These amendments revise the Technical Specifications to change the heat flux hot channel factor (F_q) to 2.18 for Units 1 and 2. These amendments also make editorial changes to the Technical Specifications.

Amendment No. 70
License No. DPR-32

SAFETY EVALUATION BY THE OFFICE OF NUCLEAR REACTOR REGULATION
RELATED TO AMENDMENT NO. 70 TO FACILITY OPERATING LICENSE NO. DPR-32
AND AMENDMENT NO. 70 TO FACILITY OPERATING LICENSE NO. DPR-37

VIRGINIA ELECTRIC AND POWER COMPANY
SURRY POWER STATION, UNIT NOS. 1 AND 2

HOT CHANNEL FACTOR NORMALIZEDOPERATING ENVELOPESURRY POWER STATION

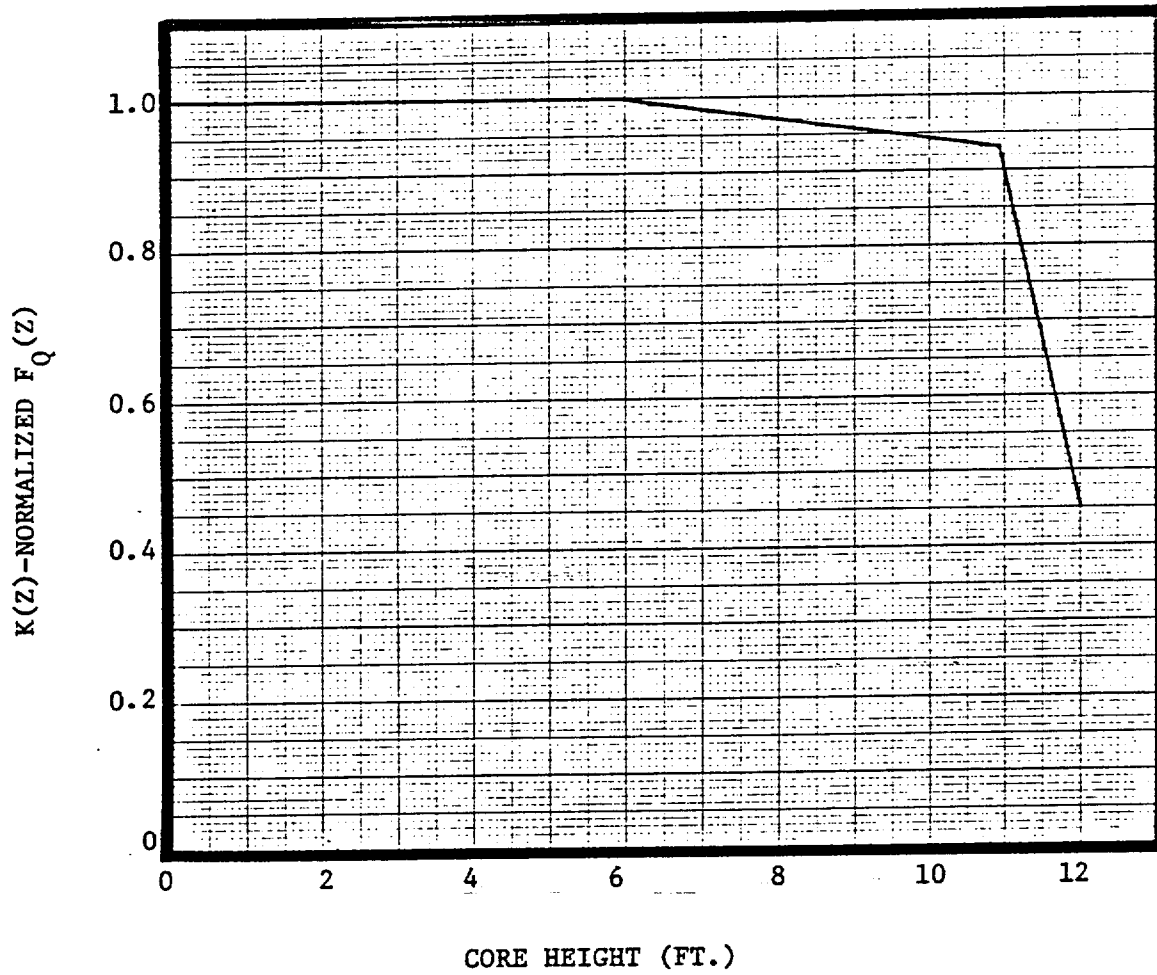
$$F_Q(Z) \leq 2.18/P \times K(Z) \text{ for } P > 0.5$$

where P is the fraction of rated power at which the core is operating, K(Z) is the function given in TS Figure 3.12-8, and Z is the core height location of F_Q .

AXIAL FLUX DIFFERENCE LIMITS
AS A FUNCTION OF RATED POWER
SURRY POWER STATION

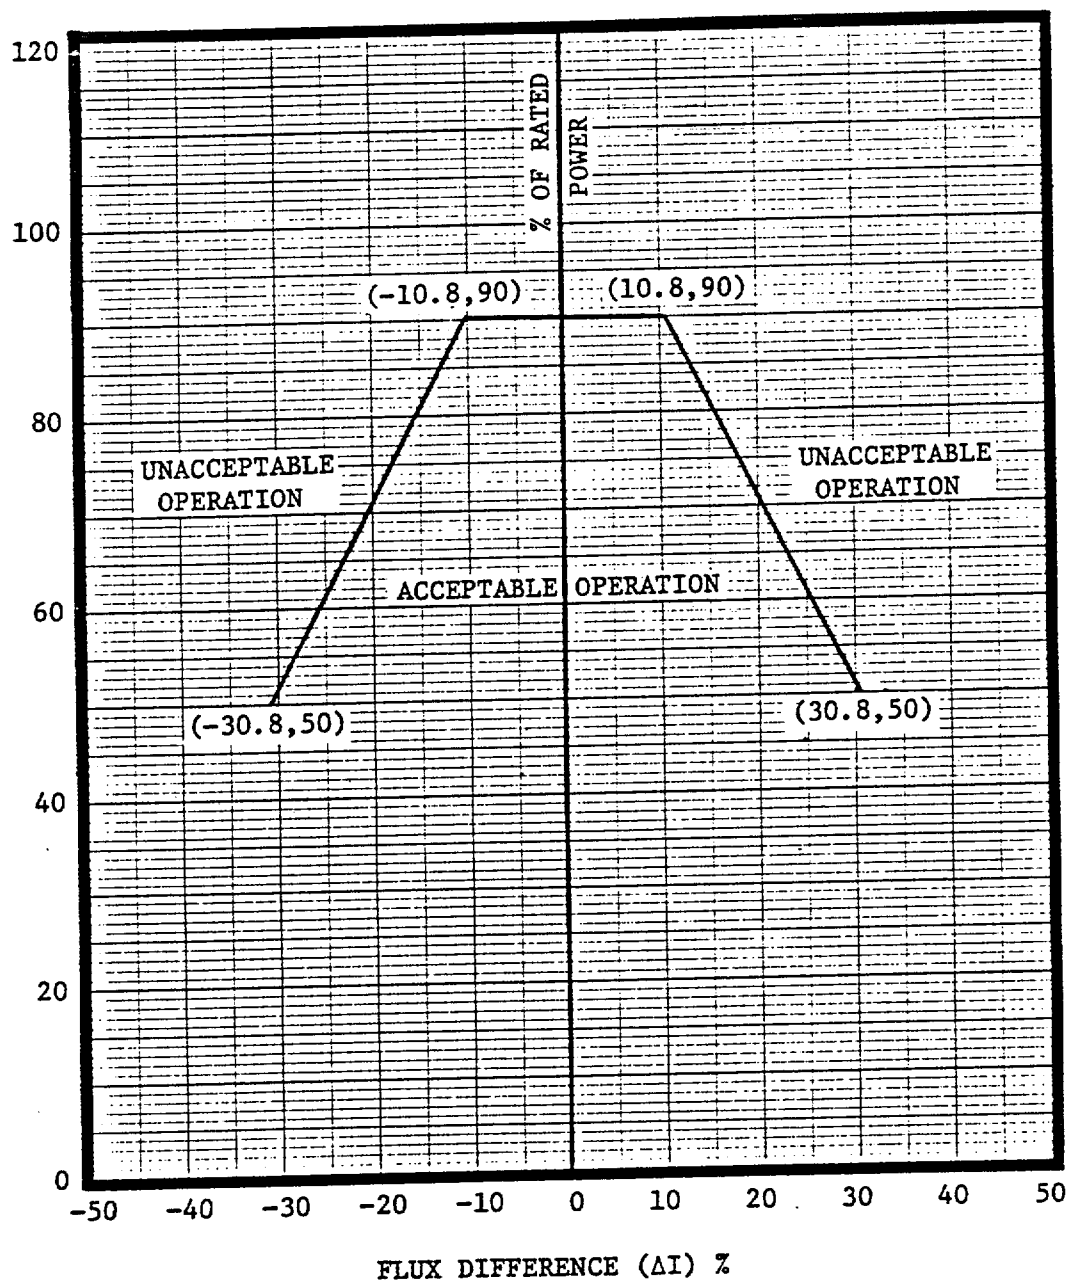
- b. At a power level no greater than 90 percent of rated power,
 - (1) The indicated axial flux difference may deviate from its target band for a maximum of one hour (cumulative) in any 24-hour period provided the flux difference is within the limits shown on TS Figure 3.12-10.
